10.0 Appendices

10.1 Ecology Mapbook	130
10.2 CMZ Mapbook	134
10.3 Preliminary Floodplain Mapbook	151
10.4 Hydrauilc Modeling Results	184
10.5 Community Comments	185

Fall River Corridor
"Plan for Resiliency"
Preliminary Floodplain Boundaries
Map 1A of 31

Draft Path to Resiliency Open House

Fall River Corridor "Plan for Resiliency" **Preliminary Floodplain Boundaries** Map 24 of 31

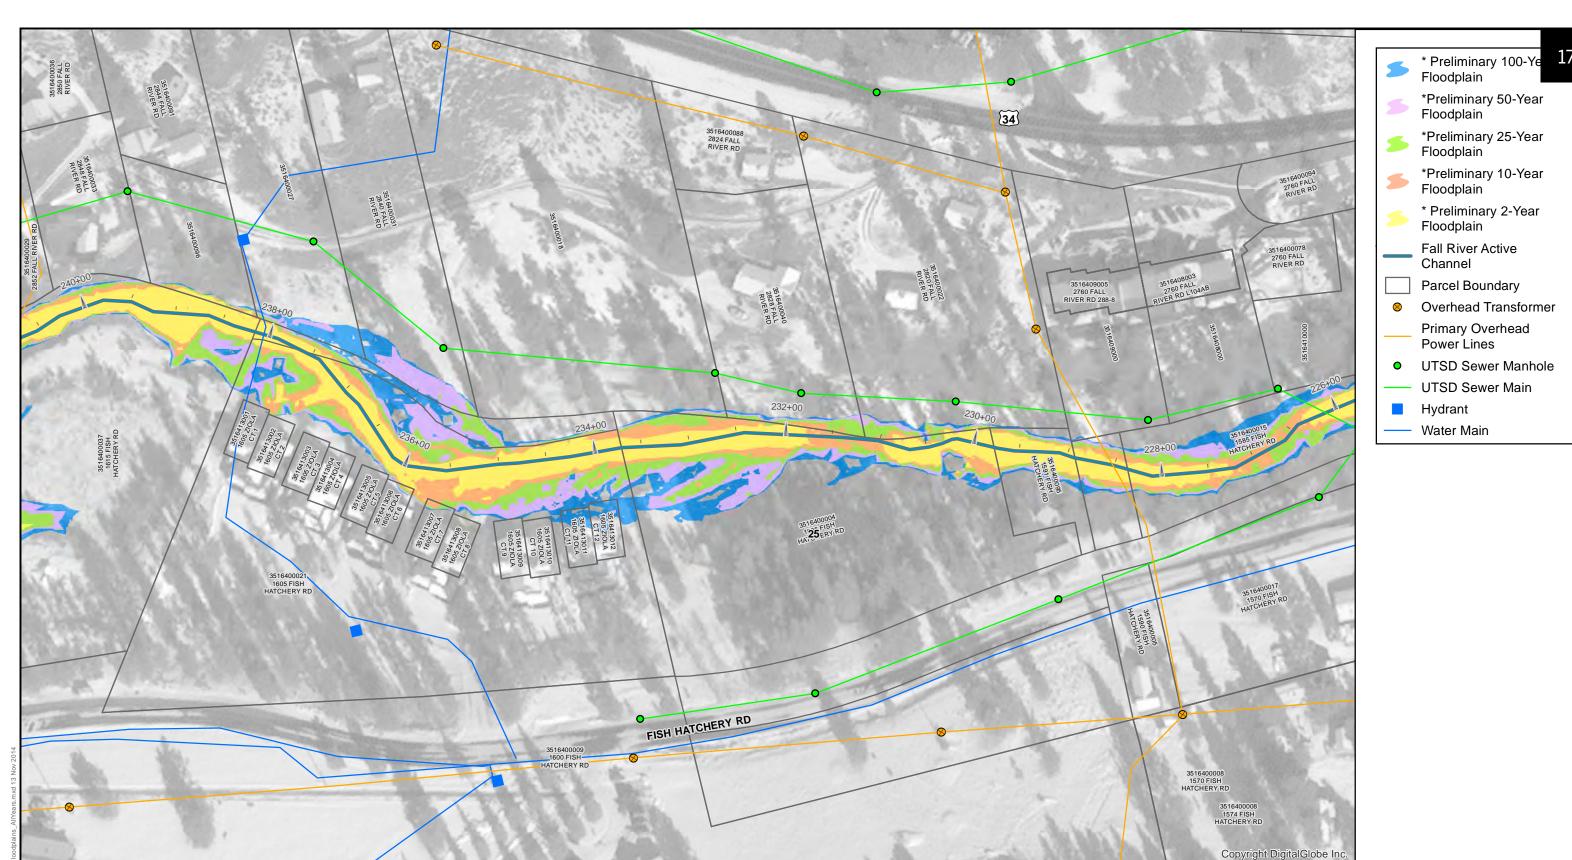
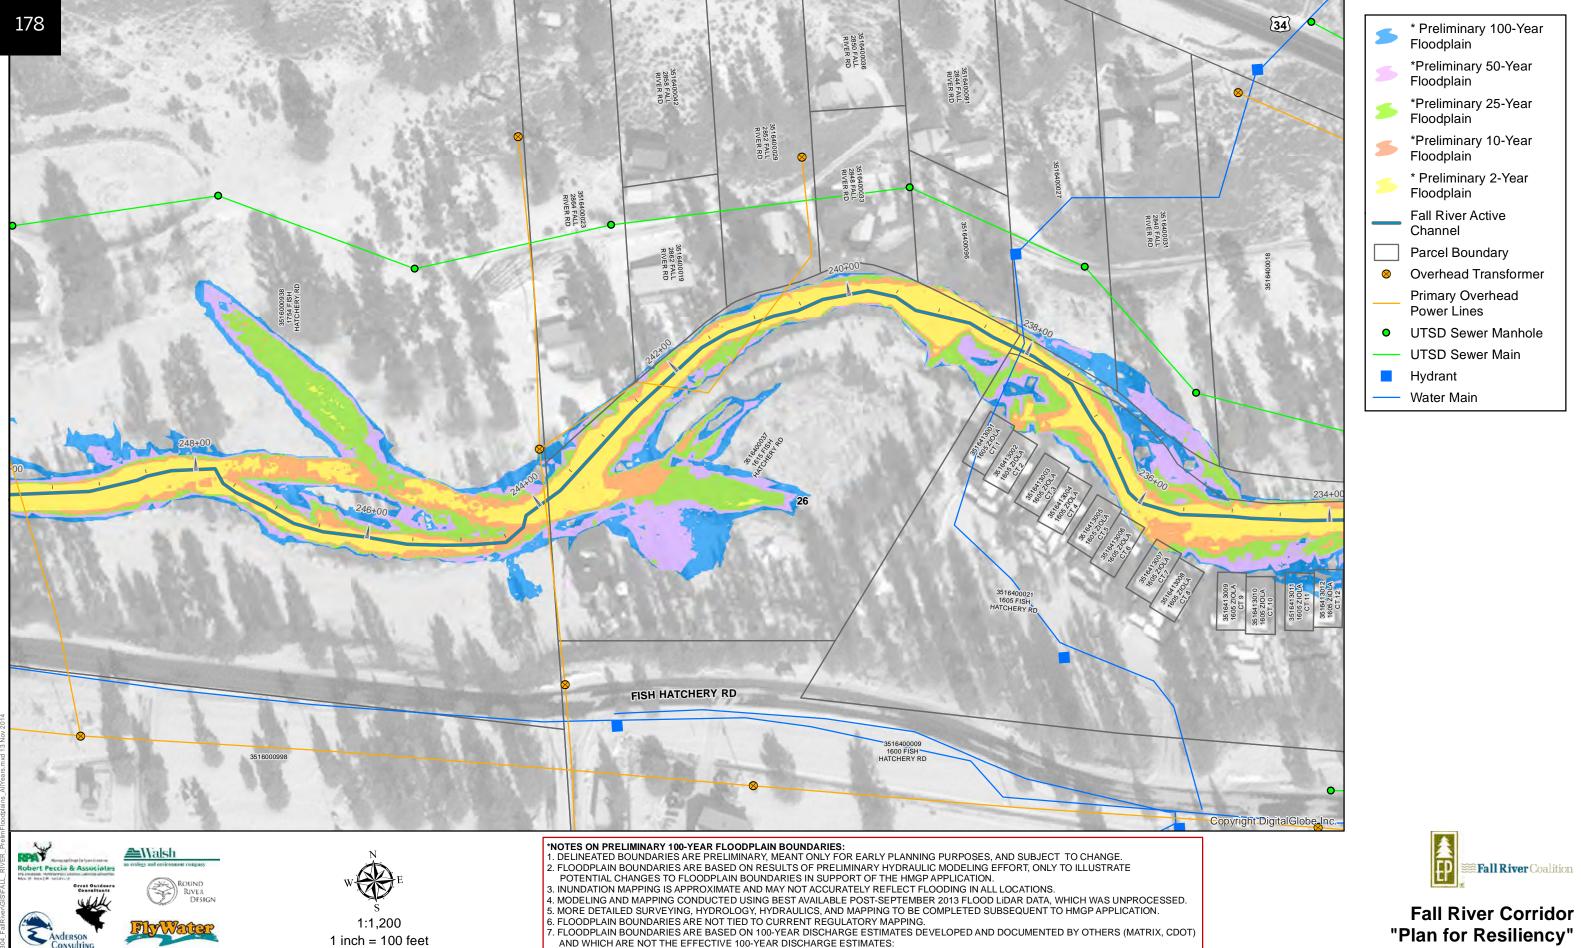
Please reference the attached revision of the Fall River Conceptual Design Master Plan proposal, submitted by Walsh Environmental et al, specifically addressing the sections on maps 23 and 24.

First and foremost, keep the river in the current channel from the area of Fawn Valley to Antlers Pointe with some minor modifications, starting upstream on map 23:

- Utilize dissipation grading from this pond to the southeast, and add step-down access to the river for wildlife.
- Curve the channel slightly southeastward, then back to the north, following the current channel, allowing some overflow channels to the southeast. This is will allow for the recreation of a wetlands area on the Oliver/Workshire property lines.

- AVOID the UTSD lines on the north side of the river channel, where the "Address Hill side Slope Drainage Issue" is indicated. This is the access road for UTSD, and was not an issue during either the 1982 or 2013 flooding events. There is hillside drainage that is a concern from the Highway 34 and MacGregor Mountain culvert. This is not included in the Master Plan.

- · Add dissipation grading below the pond through Antlers Pointe and incorporate the overflow channels from the recreated wetland area on the Oliver property.

If the current proposal by Walsh is not modified, it will negatively impact the future of Workshire Lodge as a riverside, fishing accommodation business.
